Appendix J: Surface Water Drainage – Attenuation (04/06/13)

From: Simon Lewis
Sent: 04 June 2013 08:41
To: Cathy Molloy (cathy.molloy@richmond.gov.uk)
Cc: Georgina Atkinson
Subject: Re. Twickenham - Sustainable Drainage

Project		FORMER SORTING OFFICE TWICKENHAM
Drawing Title		BELOW GROUND DRAINAGE LAYOUT
Drawn by	Checked by	Scale
PR	AD	1:200 @ A1
Drawing No.		Revision
4616/CIVIL/10		0

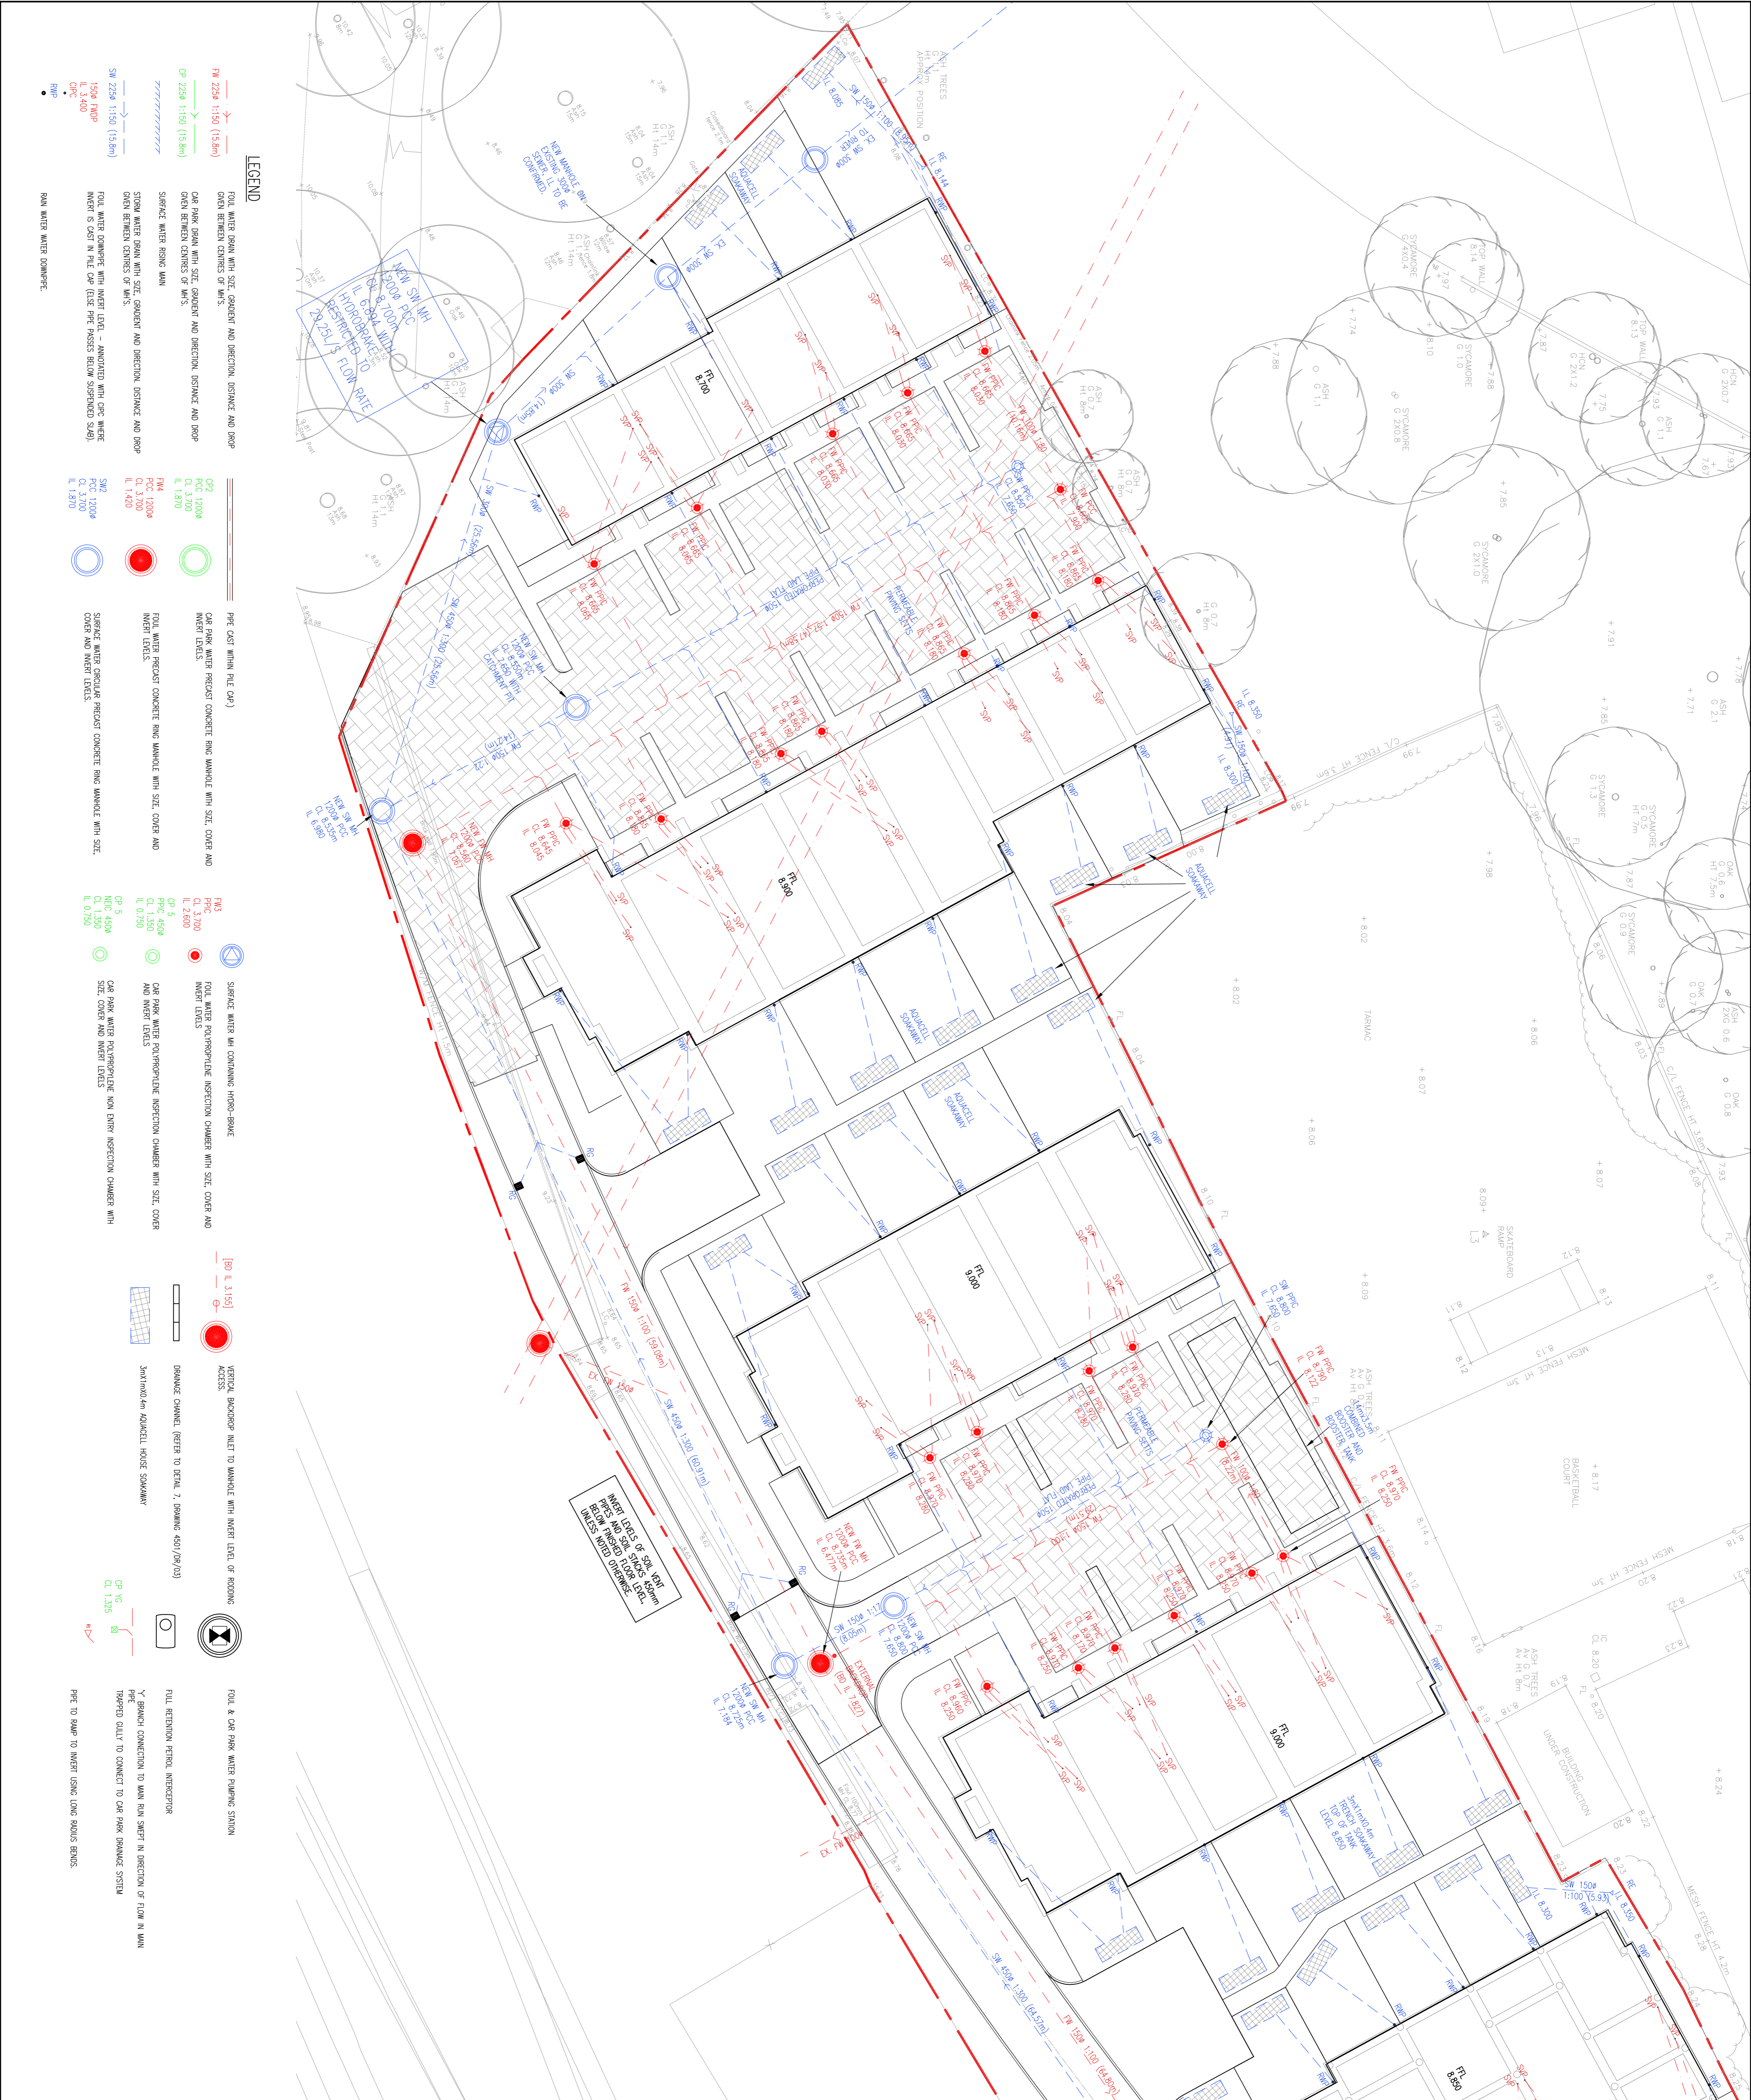
I have spoken to our Drainage Consultant on the point you raised regarding Policy DM SD7 and our sustainable drainage proposals. The following response has been prepared.

1 in 1 year (Q1) = 5.7 l/s
1 in 2.33 years (Qbar) = 6.7 l/s
1 in 30 years (Q30) = 11.6 l/s
1 in 100 years (Q100) = 13.4 l/s
- Surface water from the Site currently discharges via three outfalls. A 300mm diameter and a 225mm diameter outfall discharge directly to the River Crane (and not via public sewers) and a 150mm diameter outfall discharges to a public surface water sewer. The attached preliminary drainage design drawings show how it is intended to re-use these three connections.

- It is proposed that the sewer connection will be attenuated to the greenfield run-off rates noted above using a complex control i.e. two hydro-brakes, which will ensure that the flows for the 1 in 1 year, 1 in 30 year and 1 in 100 year + 30% are not exceeded. The catchment discharging to the sewer is relatively small comprising part of the community building roof and the section of road south of the community building.

- The drainage hierarchy has been followed in the design of the drainage:
 - 1) Water butts are to be used in order to store rainwater for later use.
 - 2) Infiltration techniques are to be used although these have had to be kept shallow to keep at least 1m above the ground water table. The upper terraces of the Apartment Block are to be Green Roof, covering an area of 466m². Planting is also to be used on the podium deck. This is currently being designed and when the areas are known this will be factored into the drainage design as it will further reduce surface water entering the drainage system and attenuate the flow rates. All of the external car parking areas and part of the access road are to be porous paving construction. All of the houses are to drain to soakaways and to the permeable car parking areas.

- 3) The flow to the existing 300mm diameter outfall will be attenuated by using a hydro-brake. The flow to the 225mm diameter outfall will be attenuated by using pumps. The storage available within the permeable paving and the piped network are sufficient to prevent any flooding during a 1 in 100 year + 30% critical storm event.

- 4) As mentioned above, the flow to the public sewer is to be restricted to greenfield flow rates using a complex control and a small storage tank will be used to prevent flooding during the 1 in 100 year + 30% critical storm.
- In summary, greenfield flow rates will be used for the discharge to the public surface water sewer. Most of surface water will drain to soakaways and permeable paving with green roofs reducing and attenuating flows. Excess flows, which will be attenuated, will discharge directly to the river.
